## Application by National Grid Electricity Transmission for the Norwich to Tilbury project

### The Examining Authority's written questions and requests for information (ExQ1): Issued on Friday 22 May 2026

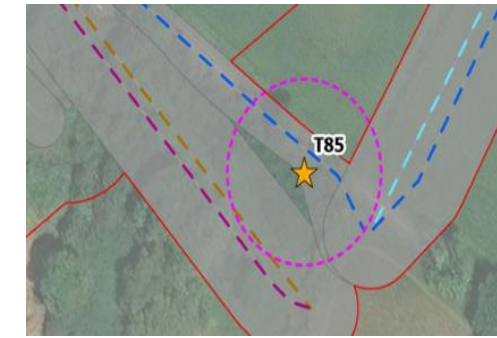
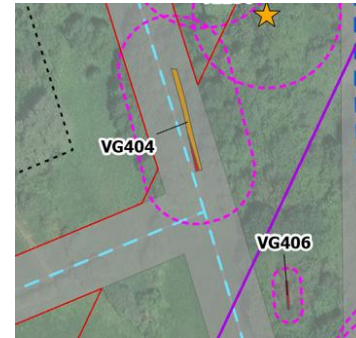
- Pre-commencement works will result in the undergrounding of the existing over-head-line. The cable will necessitate works adjacent to veteran tree group VG404, and veteran tree T85– requiring works within approximately half of the RPA. Impacts on the canopy have not been considered as this is not shown (contrary to BS5837). It is not clear if such extensive works are survivable. (Please note an alternative route was suggested by Grae Piercy in April 2025 which would reduce the damage). It is requested that an alternative, less damaging route is considered for the undergrounding of the existing overhead line.

- In the absence of topographical surveys to inform the impact assessment the extent of impact on trees is likely to be underestimated – for example veteran trees T1187-T1189 are shown as not impacted despite the internal haul road passing within the RPA and beneath the canopy (the clearance required for a Cable Drum AIL delivery vehicle is 5 m high (see [APP-310 EN020027-000188-7.3 Outline Construction Traffic Management Plan Appendix A - AIL Access Strategy.pdf](#)). It is requested the OHL through CWS 2348 is undergrounded via HDD, and measures are put in place to avoid the need for a haul road in this location – avoiding the impact on veteran trees. Failing that using helicopters to lift cable drums and install pylons should also be explored to avoid impacts to the canopy of these veterans which would likely need raising to accommodate the large lorries
